APPROACH SLAB #1

PROJECT NAME: READSBORO	PLOT DATE: 07-MAR-2012
PROJECT NUMBER: BRF 0105 (3)	DRAWN BY: G. ROKES
FILE NAME: 89J088/STR/s89J088sup.dgn	CHECKED BY: W. PELLETIER
PROJECT LEADER: J. LACROIX	SHEET 55 OF 90
DESIGNED BY: W. PELLETIER

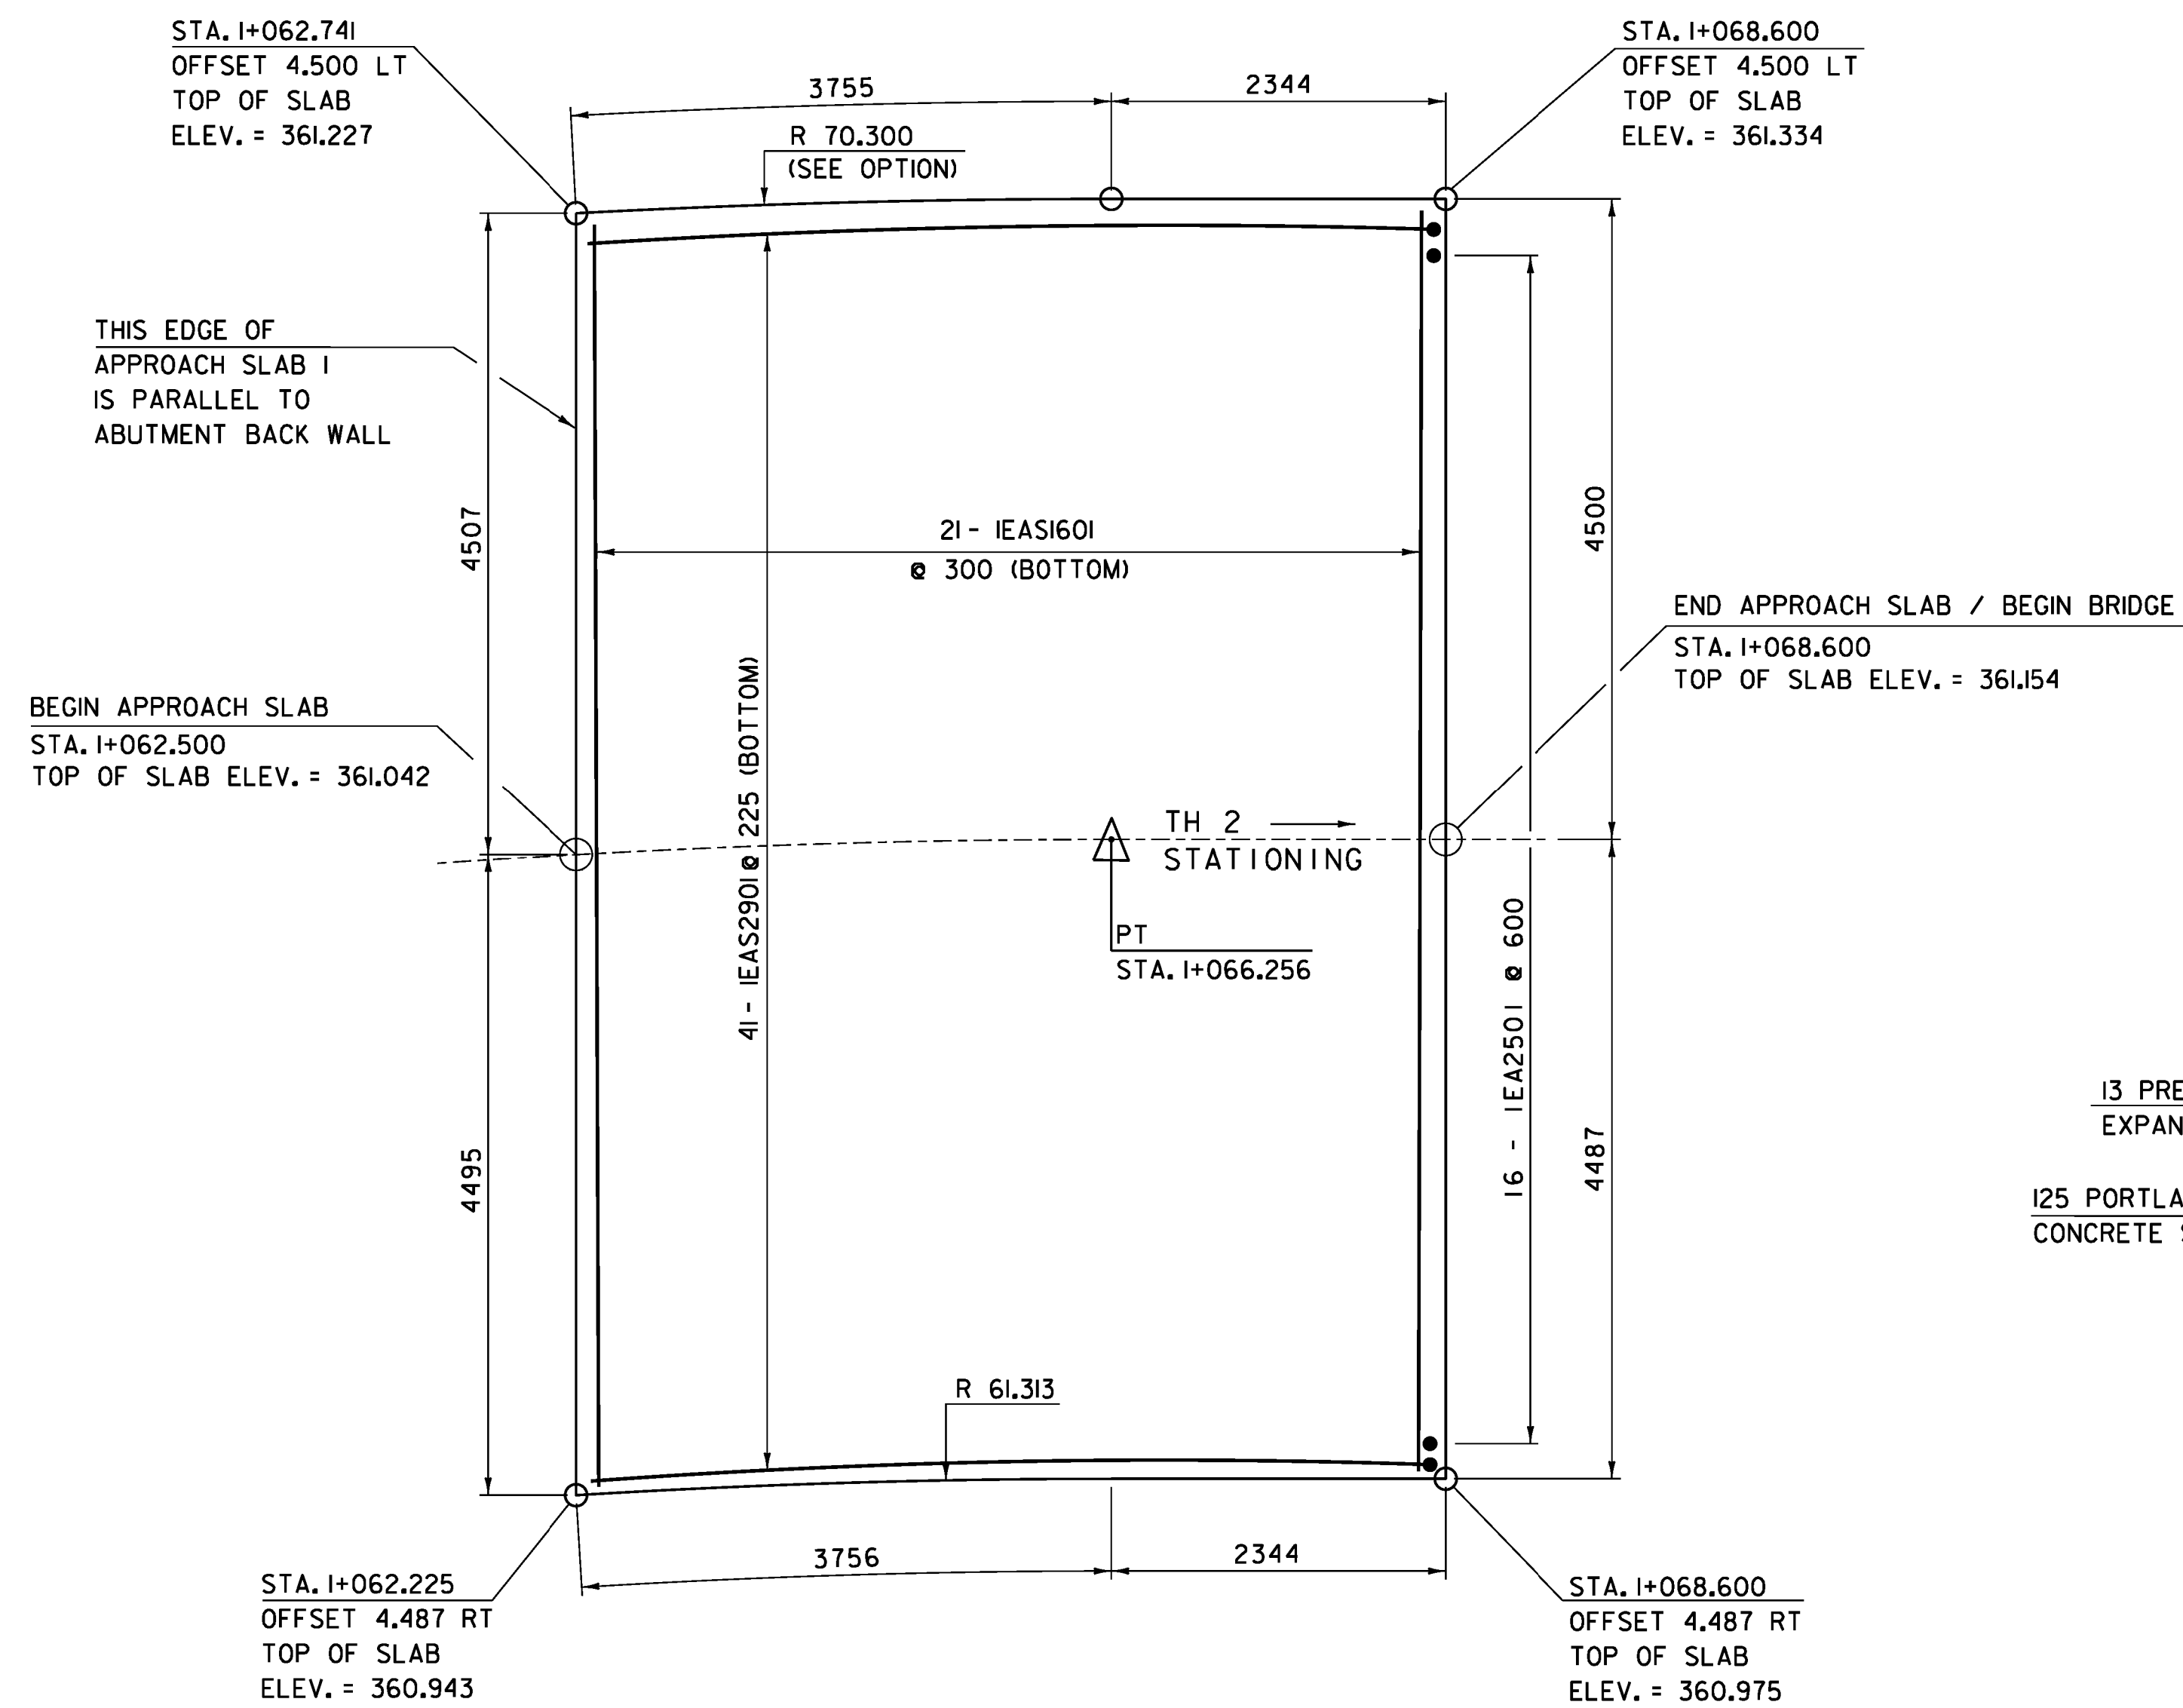
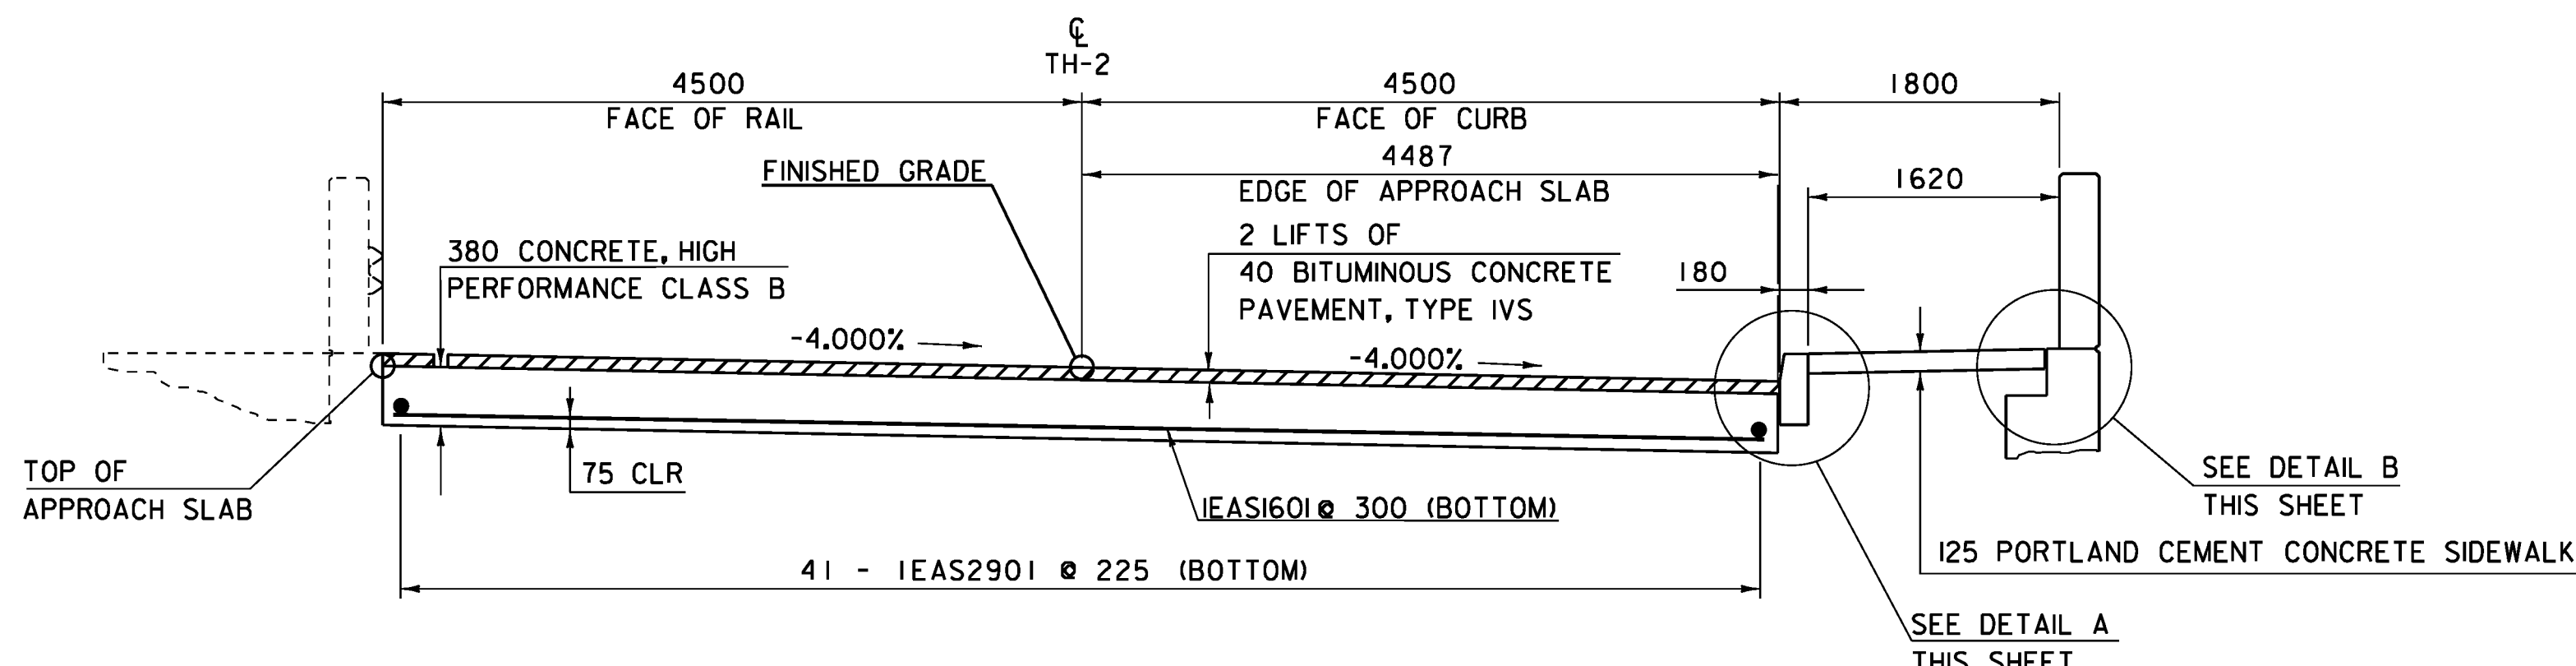
CONTRACTOR OPTION:
 APPROACH SLAB RADIUS MAY BE APPROXIMATED
 BY STRAIGHT LINE ON THIS SIDE. NO CHANGE TO
 CONCRETE QUANTITIES WILL BE ALLOWED.

CURB TAPER

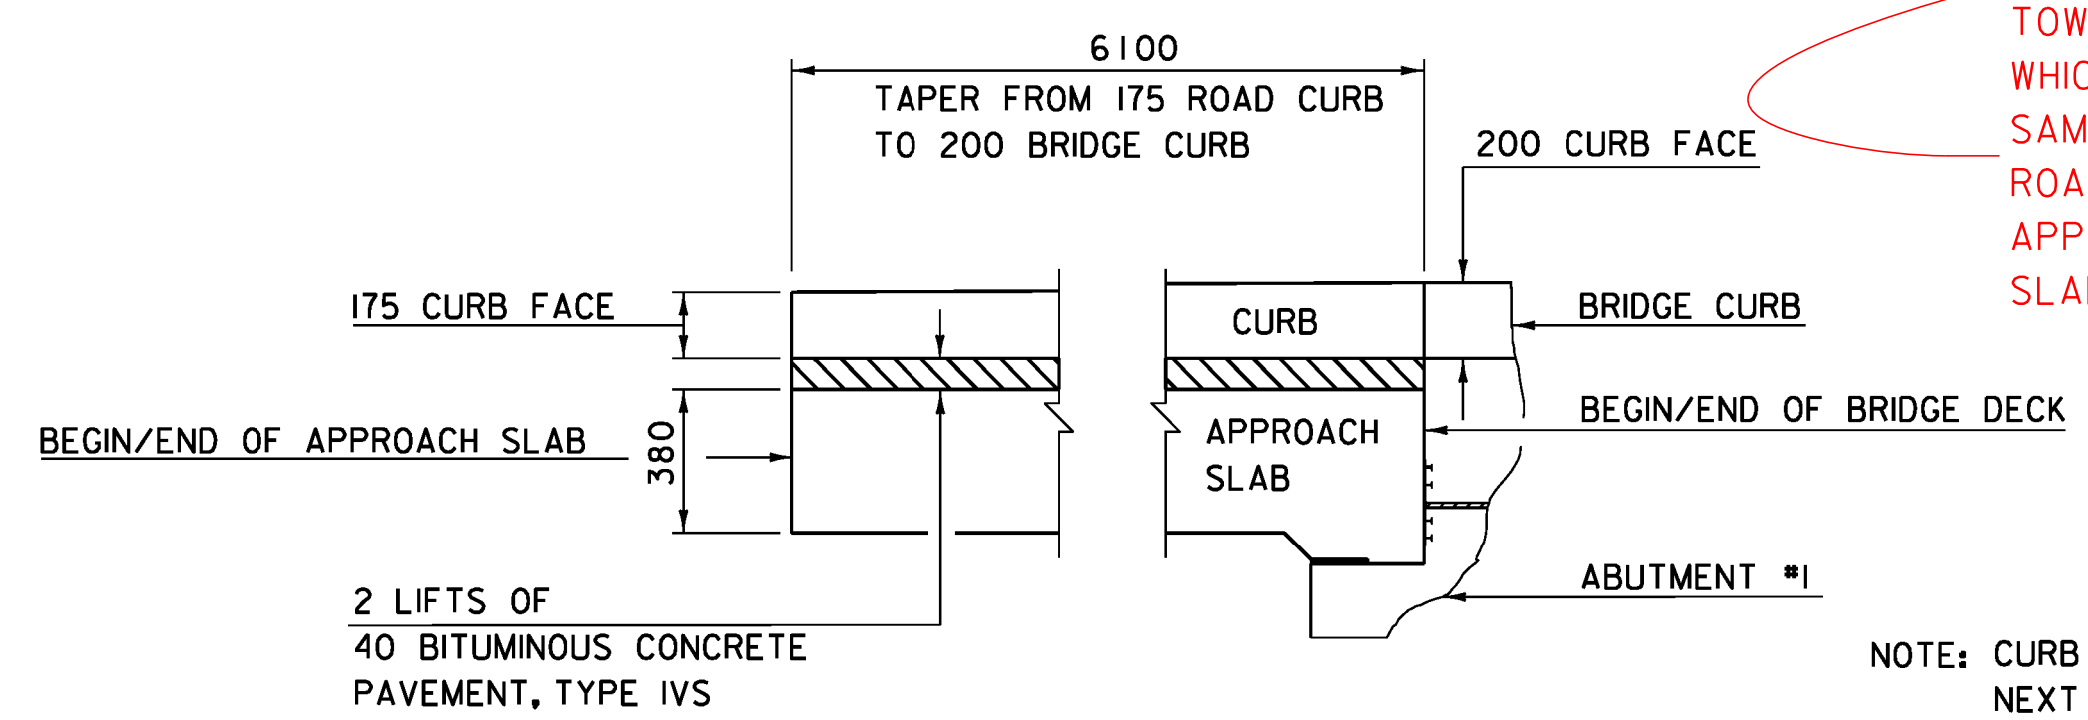
TOWN REQUESTED GRANITE CURB WHICH CONTRACTOR PLACED AT SAME PRICE. THIS WAS DONE IN ROADWAY. CURB NEXT TO APPROACH SLAB WAS POURED IN PLACE.
